To: City of the Village of Douglas Planning Commission
Date: February 1, 2024
From: Sean Homyen, Deputy Clerk
RE: 111 Wall St. Special Land Use – Residential Use of an Accessory Building

Thomas and Liana Allison, property owners, have submitted an application for Special Land Use review for the Residential Use of an Accessory Building, per Section. 26.31 of the City of the Village of Douglas Zoning Ordinance on a parcel of land described as Parcel No. 59-551-005-00, located at 111 Wall Street in the R-3, Neighborhood Conservation District. The parcel is also described as lot 5 of Spencer’s Addition plat. The subject parcel is generally located on the south side of an unimproved section of the west end of Wall Street, just west of the Wall Street / Union Street intersection.

Floor Plans

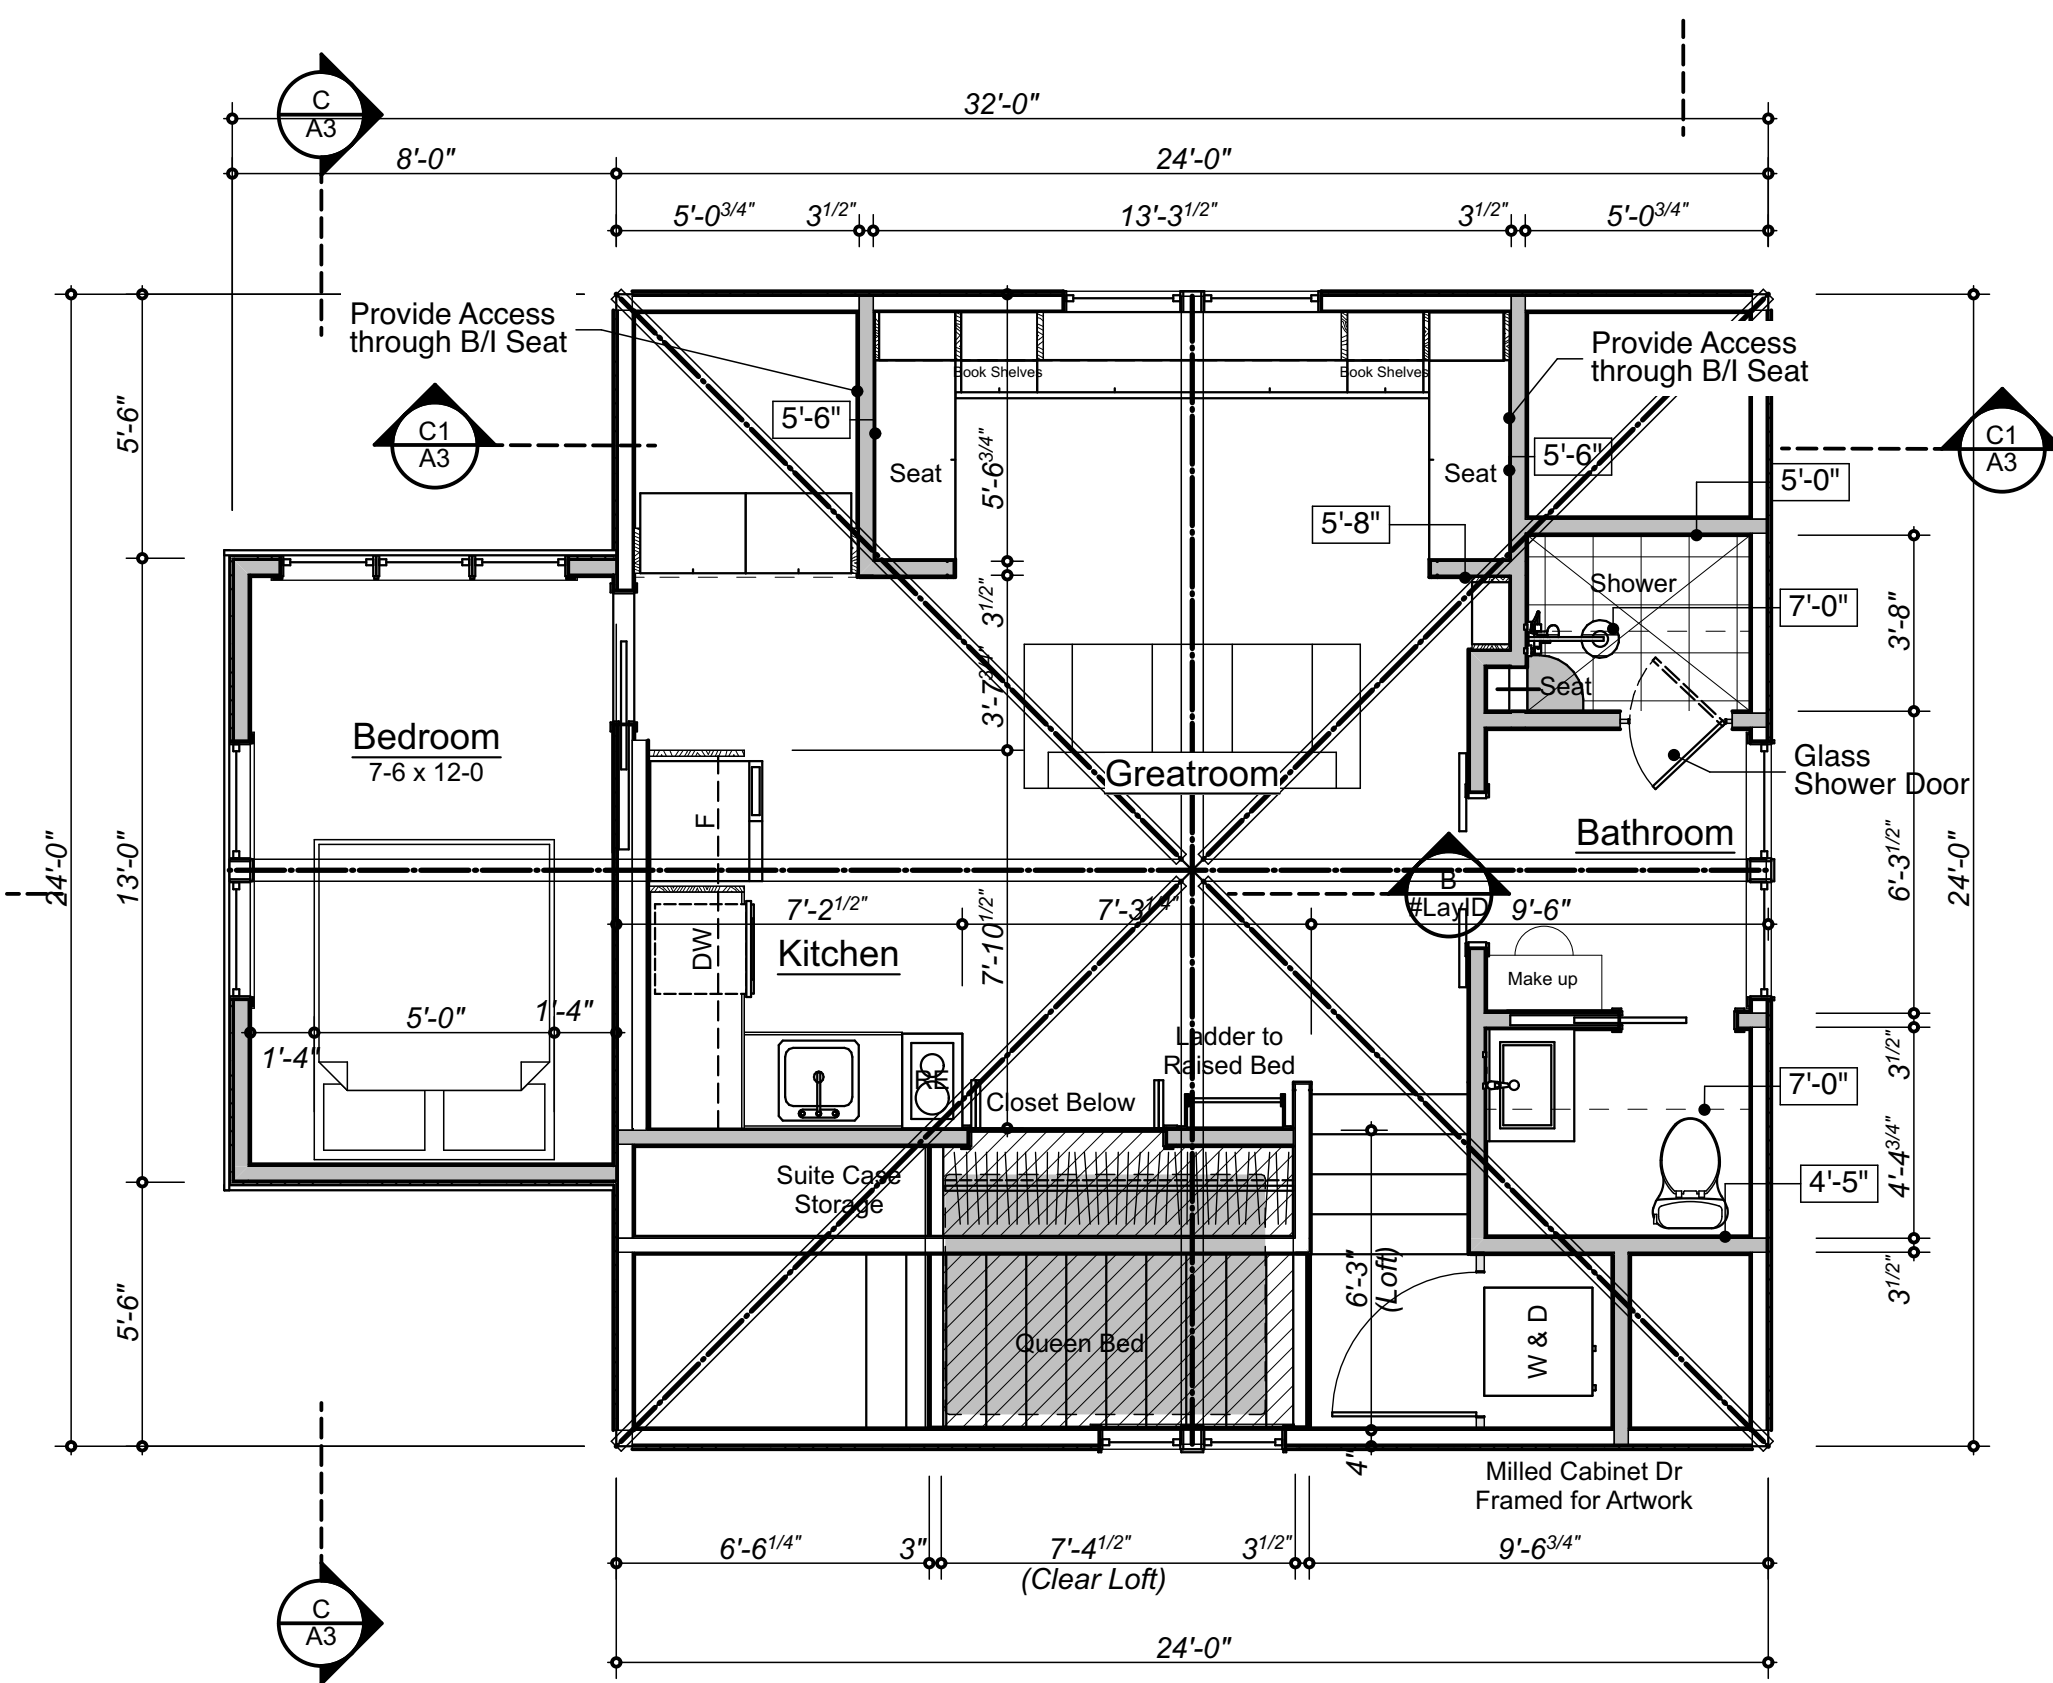
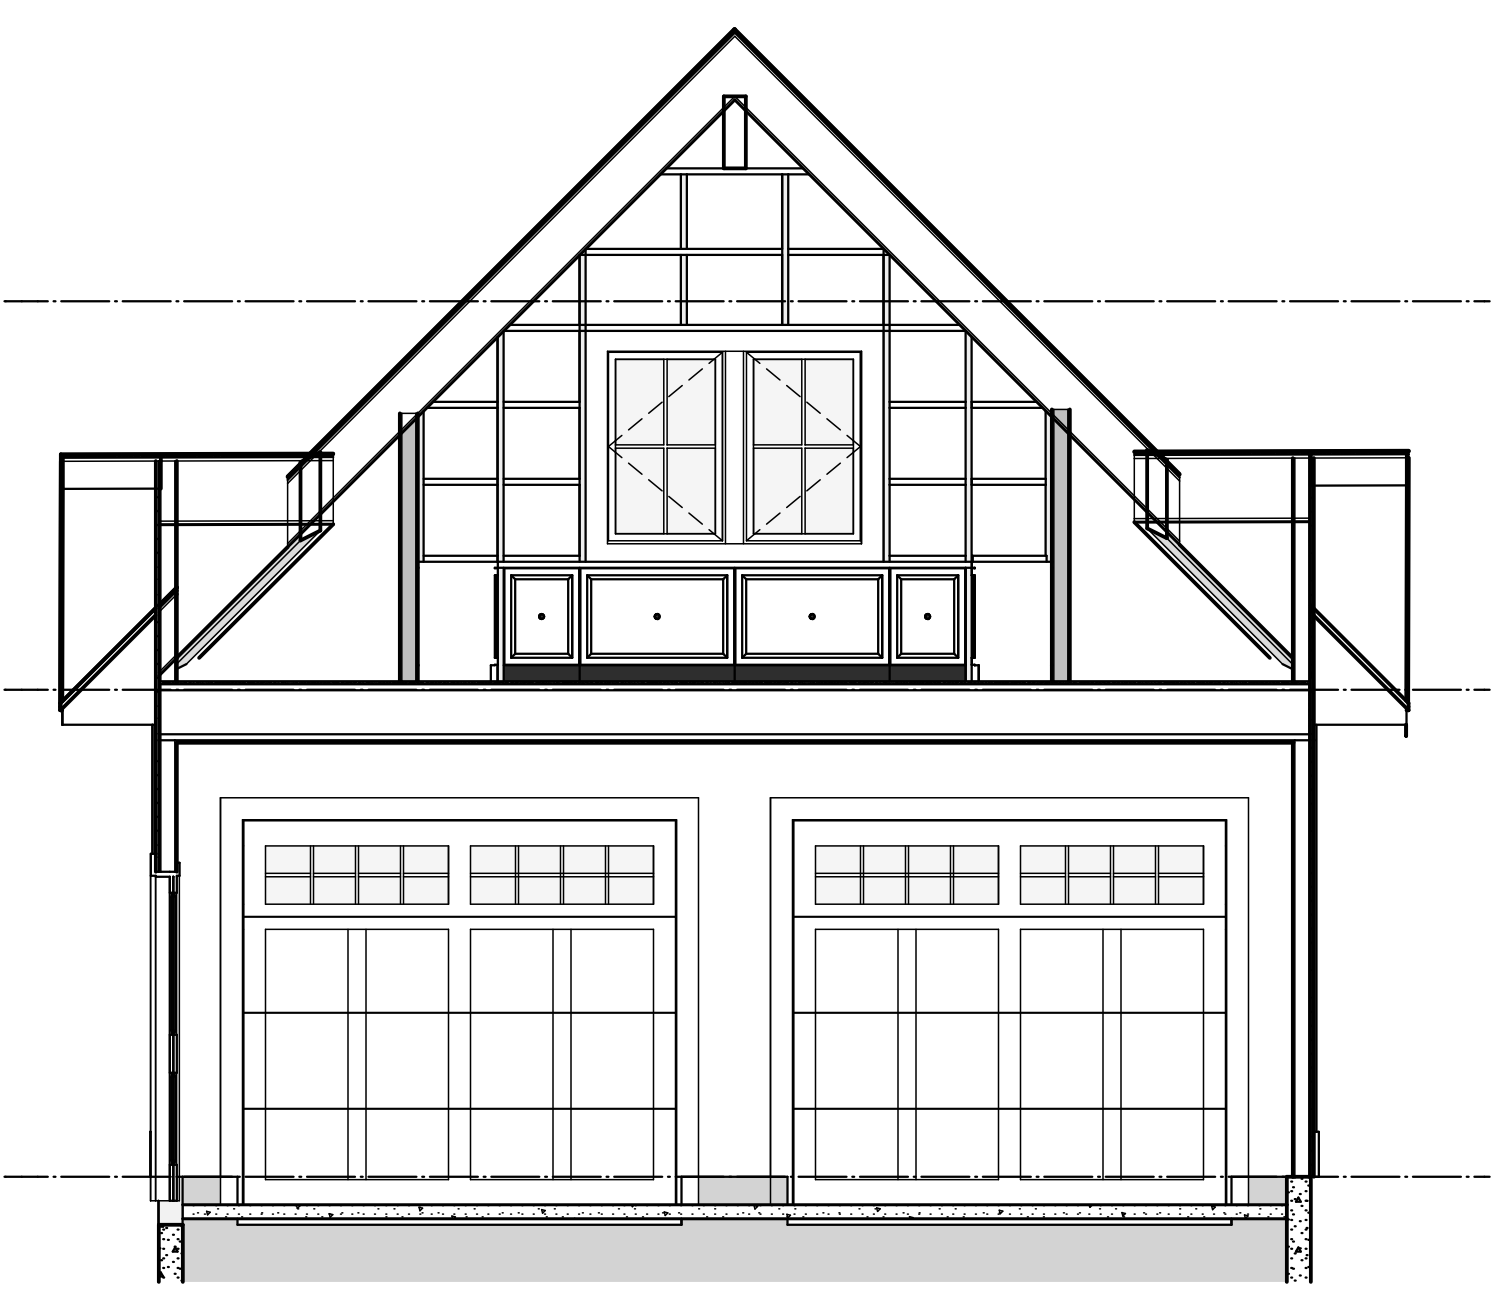
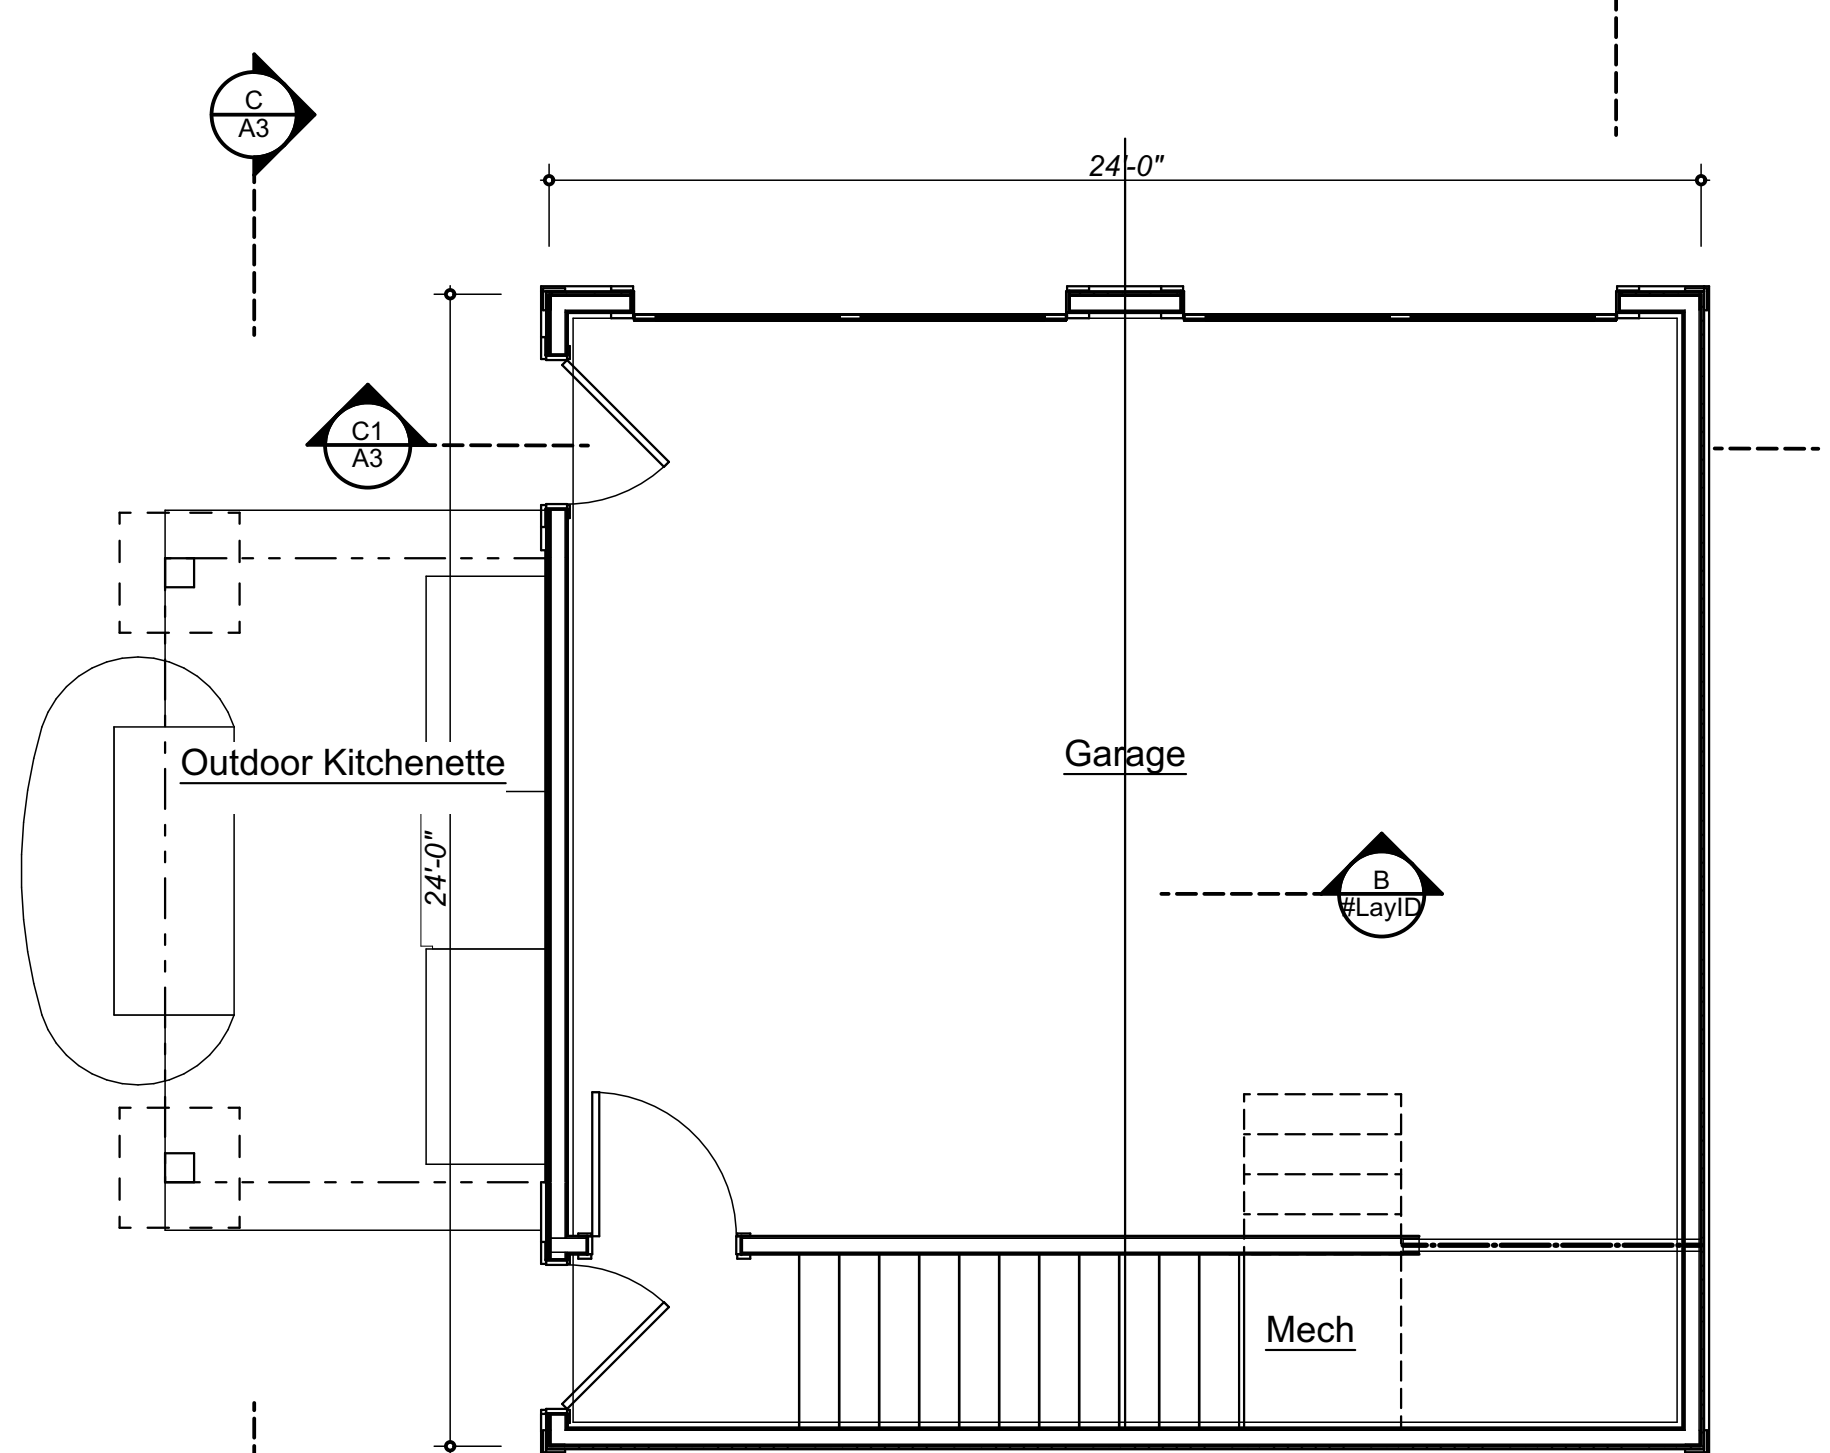
Comment: The proposed residential use is proposed on the second story of an existing accessory building. The principal building is 1,805 square feet and the proposed residential area within the existing accessory building would be 680 square feet. The square footage dedicated to half the principal structure is 902.5 square feet. Thus, this requirement is met.

Comment: The main floor of the garage is 576 SF and the second level is 680 SF. This requirement is met.
